RE: Cross Gold Mine, Permit No. M-1977-410, 110(2) Hard Rock Permit Amendment Application (AM-02), Adequacy Review No. 4

The Division of Reclamation, Mining and Safety (Division) has completed its review of your adequacy response for Amendment No. 2 (AM-02), received on January 21, 2022. The Division has identified adequacy items in the application requiring additional information or clarification. These items are identified below under their respective exhibit heading, and are numbered sequentially.

Account Number:	R0091749
Owner:	U S GOVERNMENT
Mailing Address:	
City:	WASHINGTON DC
Zip:	20001
Sec-Town-Range:	09 -1S -73
Subdivision:	TR, NBR 920 ELDORA AREA
Market Area:	620

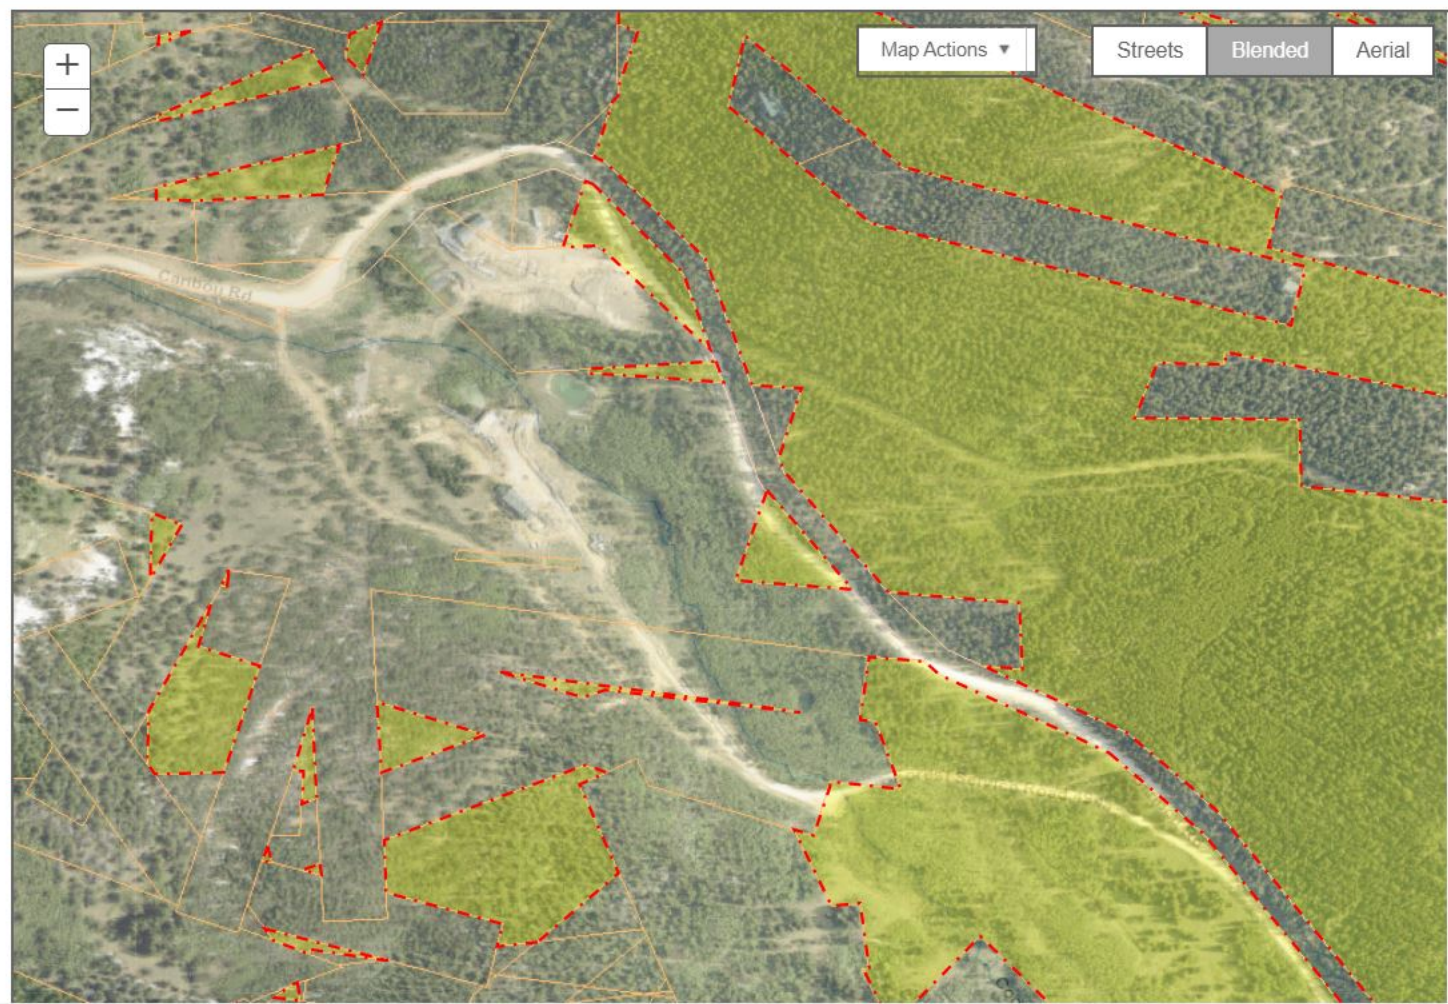
- 4) For Map 2, the Division has the following comments:
 - a. Please include the names of all landowners within 200 feet of the proposed permit boundary, particularly the USFS, which owns land directly east of the proposed Cross-Caribou permit area (see enclosed screen capture of this parcel from Boulder County Assessor's website).

Account Number:	R0028464
Owner:	NORTON EDWARD & RECECCA SUE PRONTO
Mailing Address:	13881 GAYLORD ST
City:	BRIGHTON CO
Zip:	80602-6367
Sec-Town-Range:	08 -1S -73
Subdivision:	MINING CLAIMS
Market Area:	002

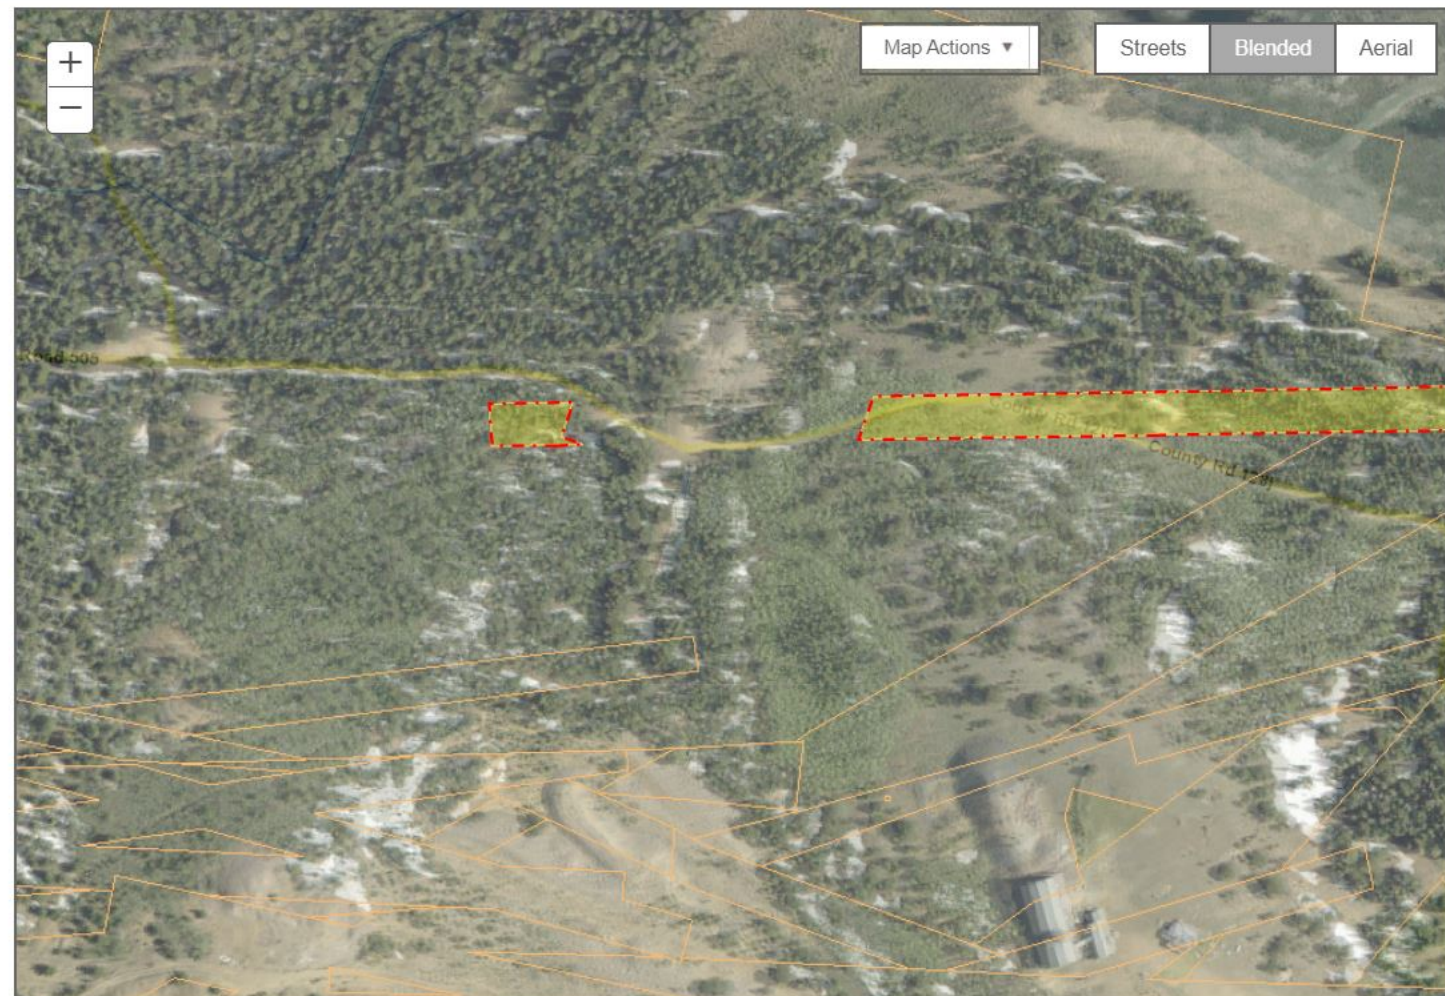
- a. Please ensure the names of all landowners within 200 feet of the proposed permit boundaries are correct. According to the Boulder County Assessor's website, the parcel located west of the proposed Caribou 300 Level Portal permit area which is labeled "Aardvark Agencies Inc." is actually owned by "Edward Norton and Rebecca Sue Pronto". Additionally, the Assessor's website shows the parcel located the closest to the southern boundary of the proposed Caribou 300 Level Portal permit area which is labeled "Robert P Fullerton" is actually owned by "William D. Backman Jr". Screen captures of these parcels from the Boulder County Assessor's website are enclosed.
